Project: Pitchcombe Junction Revision A

Subject: Development of Design Proposals Provided by Gloucestershire Highways

The aim of this technical note is to explain the issues related to implementing the design provided by GH.

A46 SB TO A4173 NB. 16.5m ARTICULATED

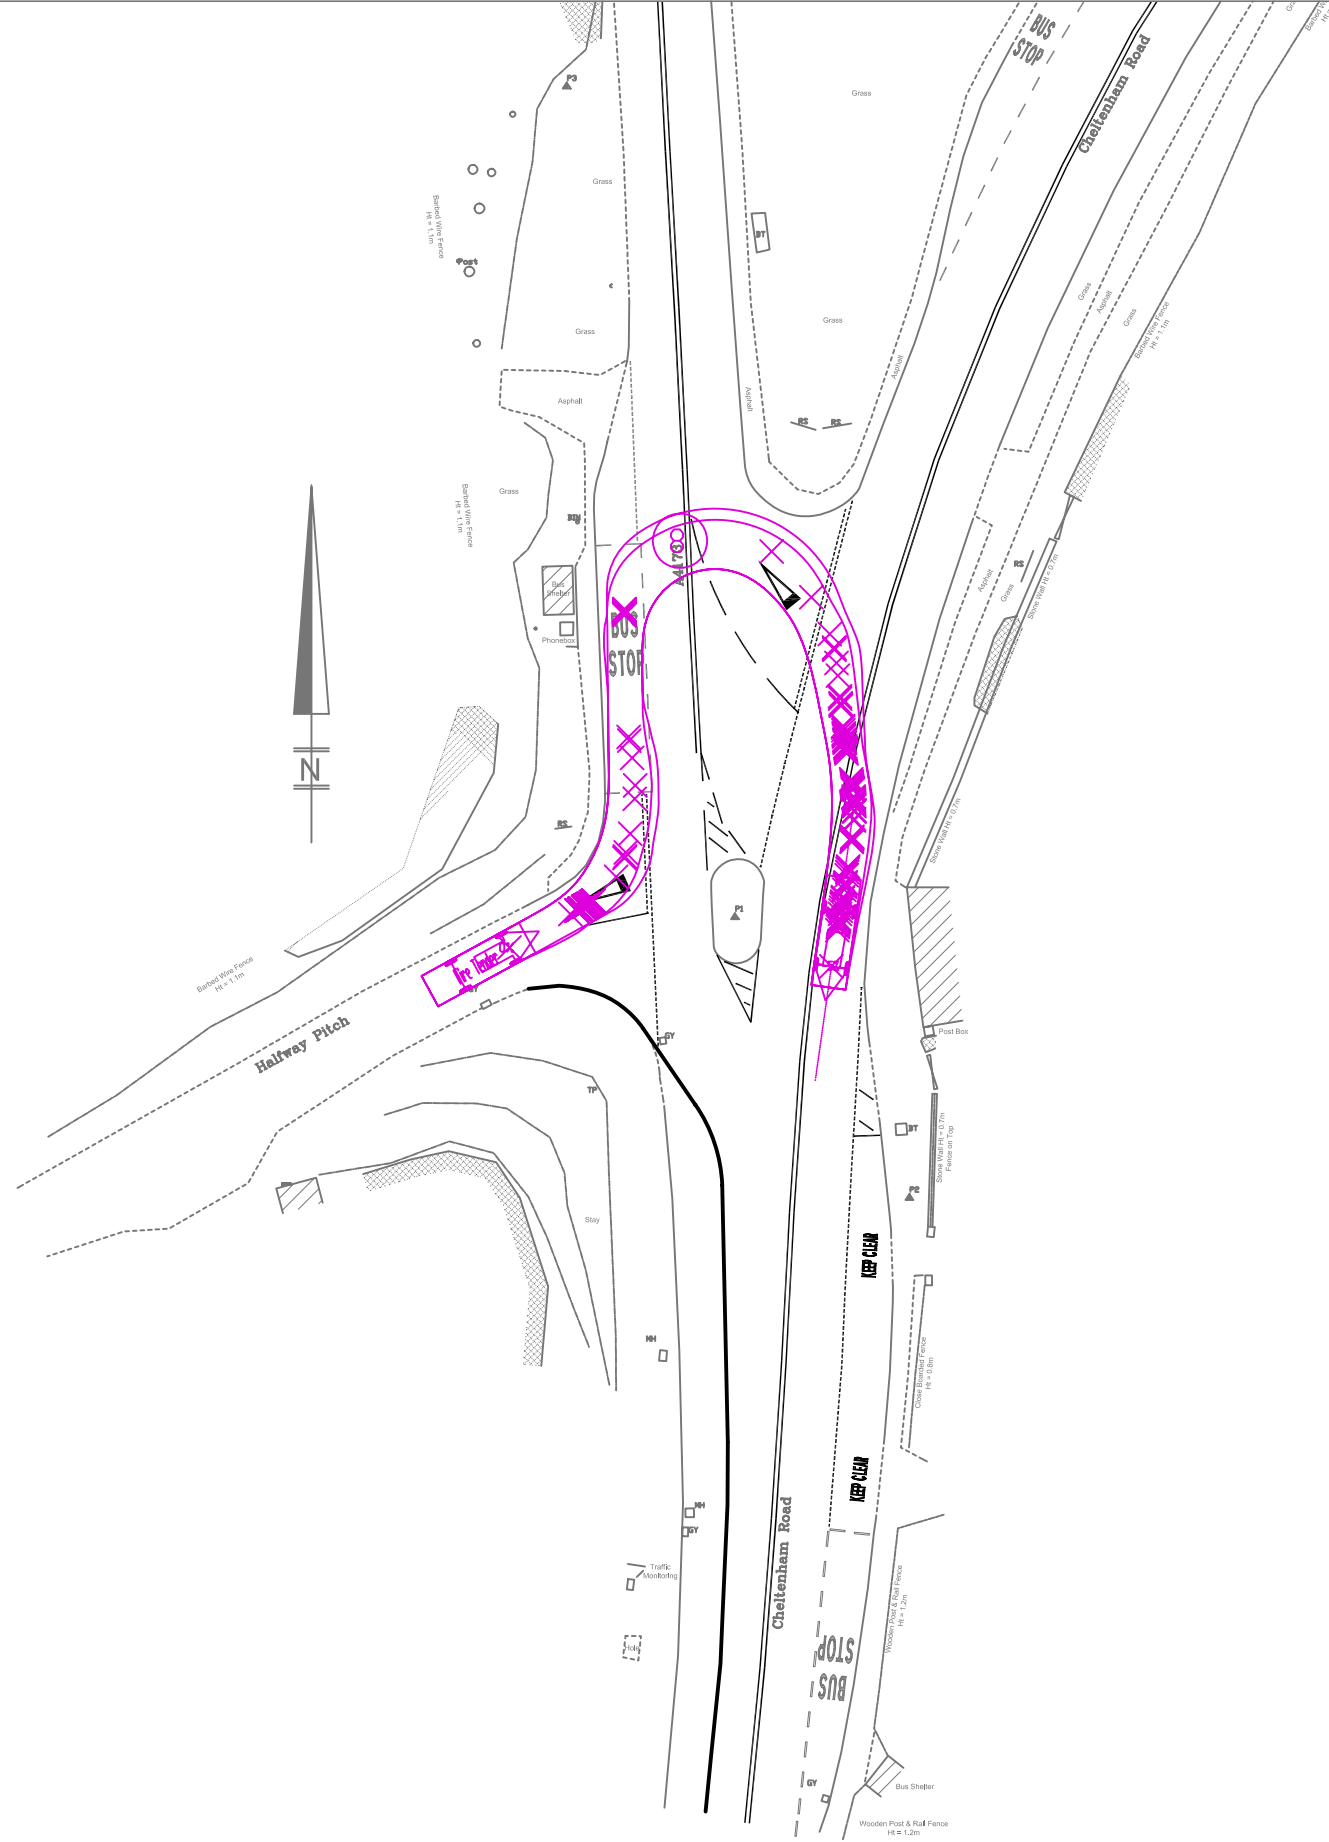
The proposed design was checked using Autotrack software to ensure that the following movements are achievable: the design vehicles were a 16.5 metres articulated vehicle and a fire tender.

- Right turn movement off the A4173 and onto the A46 southbound
- Right turn movement off the A46 southbound and onto the A4173 northbound
- Continuing left on the A4173 northbound off the A46 northbound
- Right turn out of Halfway Pitch onto the southbound lane of the A46 .Due to the presence of existing and proposed island this manoeuvre can only be achieved if vehicles initially make a left turn onto the A4173 before turning right onto the A46. It is suggested that hatched road markings are introduced along the top edge of the proposed island in order to encourage

vehicles to use the widened carriageway (including the incorporated bus lay-by space) and ultimately further facilitate this difficult manoeuvre.

It is important to note that the tracking of vehicle movements dictated the layout of the junction. This resulted in the size of the island being smaller than that proposed by GH and a very wide junction between the A46 and the A4173.

The tracking of the turning manoeuvres shows that all these movements can be accommodated within the existing carriageway boundary and no land acquisition will be necessary other than the incorporation of the bus lay-by. However, the vehicle movements are far from ideal and whilst technically possible some of the more difficult manoeuvres would be at the limit of the design vehicle's capability.

Two right turn bans will be required to enable this junction layout to work. They are the movement from the A46 southbound to Halfway Pitch and the movement out of Halfway Pitch southbound onto the A46. This latter movement could be accommodated by initially turning left onto the A4173 and heading north for a short distance before undertaking a 180° turn into the A4173 junction with the A46. This manoeuvre would be difficult for anything larger than a car and impossible for anything larger than a fire tender. Furthermore, if there is 1 or more vehicle already queuing at the A4173 southbound give way line then it is not possible for any vehicle to make this manoeuvre.

REVIEW OF DESIGN PROPOSALS SUBMITTED
BY GLOUCESTERSHIRE HIGHWAYS

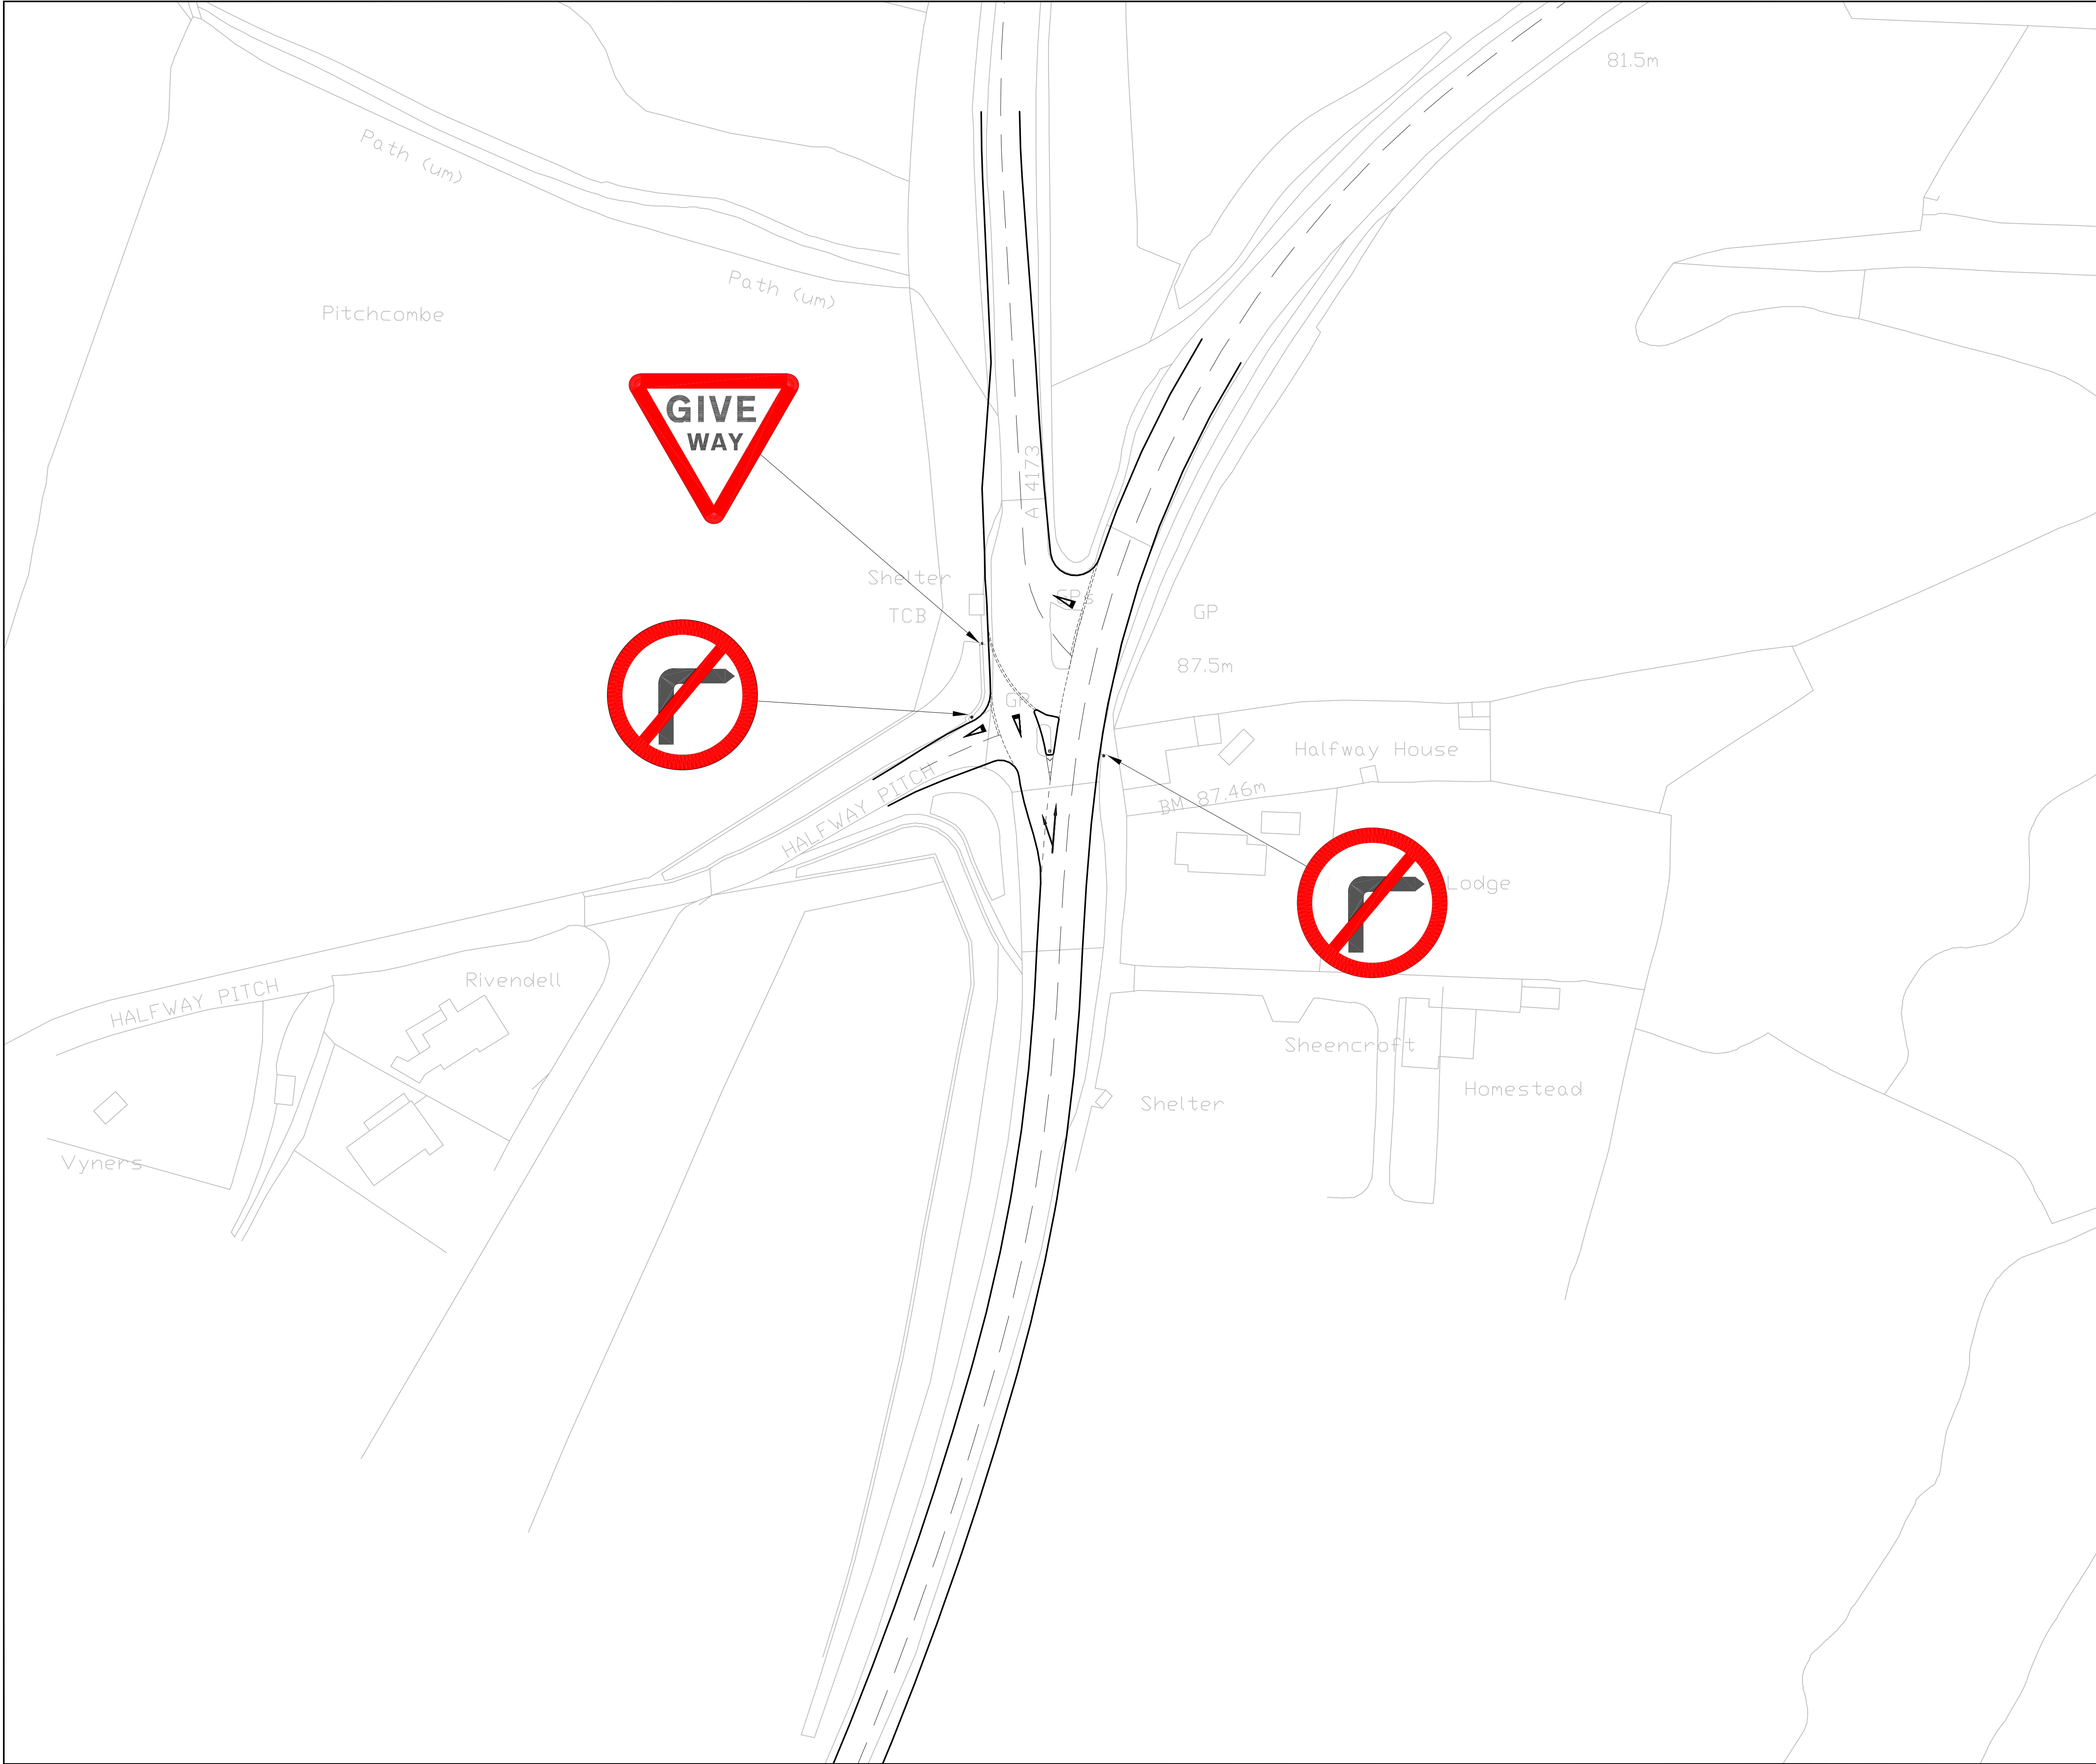
The design proposals submitted by GH aim to increase junction visibility which is achieved through the following:

- Narrowing the northbound section of the A46 to one lane only by removing the A4173 off-slip. This would also prevent vehicles travelling southbound along the A46 from entering the Halfway Pitch.
- Incorporating the bus lay-by along the northbound lane of the A4173 into the carriageway space and relocating the bus lay-by. This aims to increase the space available for turning movements from Halfway Pitch into both the northbound and southbound lanes of the A46.
- Reducing carriageway levels south of the junction to improve forward visibility on the A46 and for southbound vehicles queuing at the junction.

In some respects the operation of the junction under the proposed scheme would not be that different from existing but in others it would be worse. The main reason for making changes to the junction is presumably to alleviate the difficulty experienced by southbound A4173 traffic trying to join the A46 southbound. The only benefit of the proposals to these drivers would be the increased visibility if the vertical alignment is amended. However, as has been clearly demonstrated, this aspect of the proposal is extremely unlikely to be taken forward. Without this there is little if any benefit in amending the horizontal alignment in line with the proposal.

The A46 southbound to A4173 northbound manoeuvre is currently not possible due to the geometry of the junction but this could be achieved with the proposed alignment. However, it is not clear what demand exists for this movement or even if this is a priority of the scheme. Traffic that needs to make this manoeuvre is currently making alternative arrangements and it is possible that the existing arrangements (such as using the local road network north of the junction to change routes or turning around at some point south of the junction) may be satisfactory in relation to the demand.

The movements into and out of Halfway Pitch would not change significantly but there would be a slight benefit for traffic turning south out of the junction onto the A46 since the junction would effectively be moved further north, giving a greater turning area. However, if the vertical alignment were to be amended then the side road would be even steeper and some of this already small benefit would be lost.

The main disadvantage of the proposal is for northbound vehicles on the A46 turning off onto the A4173. This manoeuvre would become unnecessarily complicated and potentially dangerous as vehicles would have to give way to southbound A46 to northbound A4173 traffic. Whilst this may not happen very often it is potentially a dangerous situation.
